TAKACHI**TAKACHI ELECTRONICS ENCLOSURE CO., LTD.**

NOTICE

ALUMINIUM MOUNTNG PLATE for FCS • FCWS - FCSC Series Changes to Number of Brackets and Installation Holes

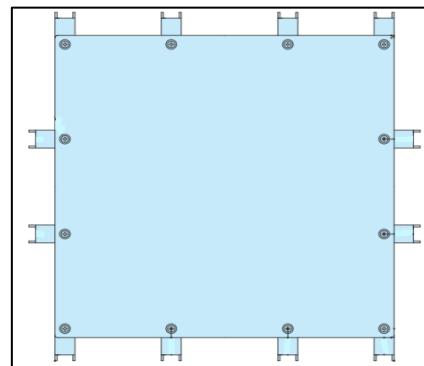
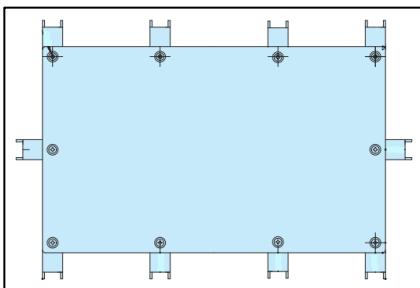
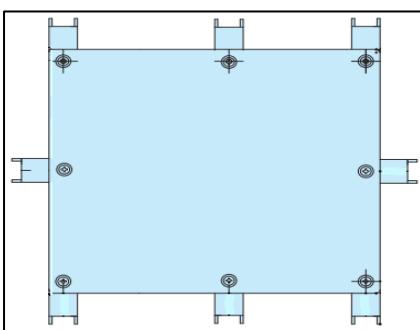
■ Changes : Number of brackets and installation holes.

Current (Old) Bracket and Installation Holes - 10 pcs / 12 pcs type

Case W Dimension	Case D Dimension	Brackets
601～1000mm	400～600mm	10 pcs
400～600mm	601～1000mm	10 pcs

Case W Dimension	Case D Dimension	Brackets
601～1000mm	601～1000mm	12 pcs

New Bracket and Installation Holes - 8 pcs type

Case W Dimension	Case D Dimension	Brackets
400～1000mm	400～1000mm	8 pcs

- Purpose: To ensure consistent quality throughout via streamlined supply chain and materials.
- Effective Date : Changes will take place from orders received from May 1, 2022.
- Note 1: No changes to the matching size of FCS and FCWS series.
- Note 2: No changes to material and color.
- Note 3: No changes to item product number or pricing.
